DR4500 Enhancements (Ver 10.59) - 7/99 Internal Cascade

DR4500 Before Enhancements - 7/99

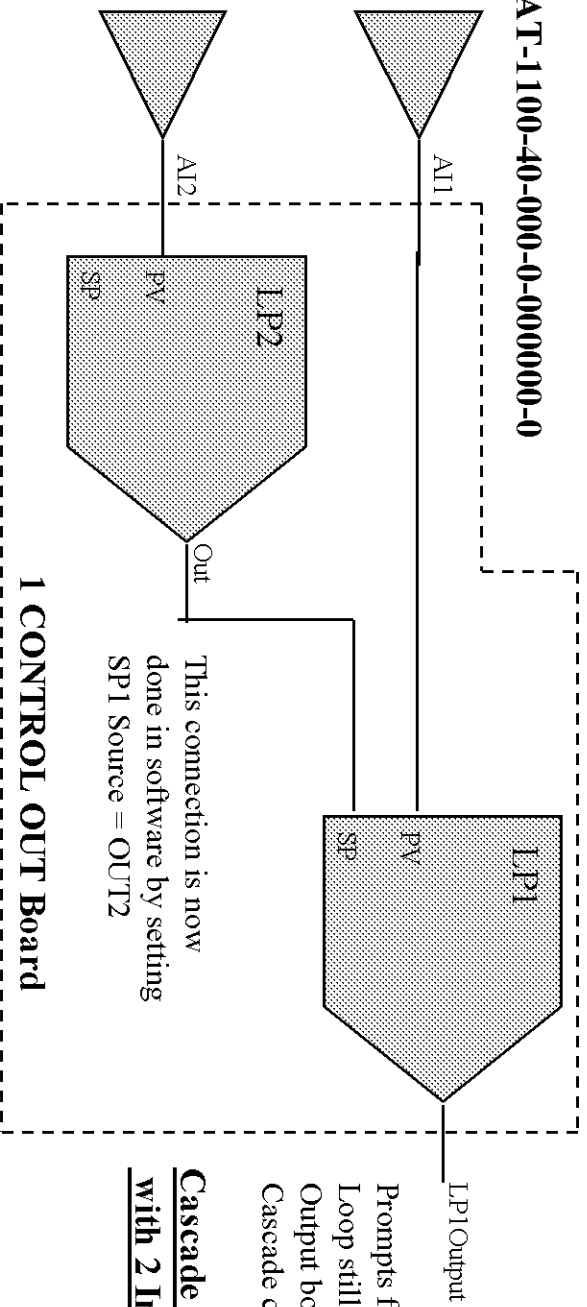
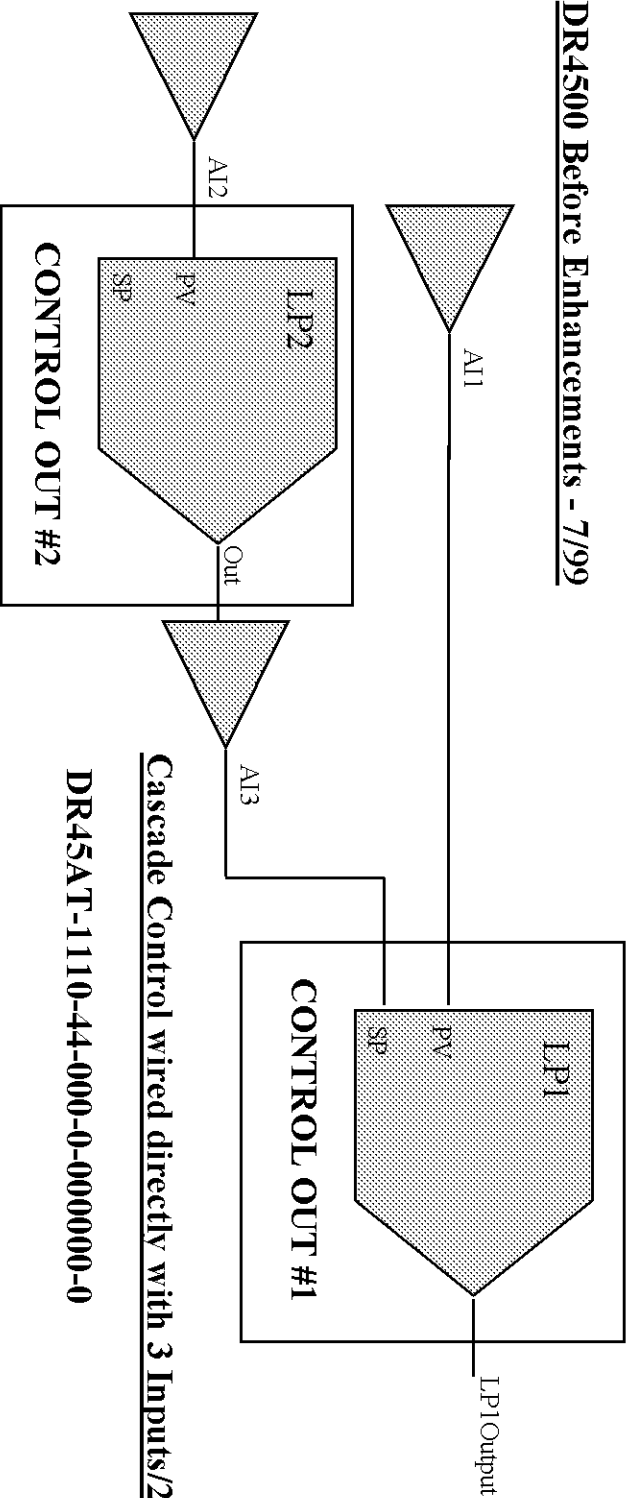
Prompts for each Control Loop still show up but only 1 Output board is require for the Cascade control

Cascade Control done directly with 2 Inputs/1 Output

Cascade Control wired directly with 3 Inputs/2 Outputs
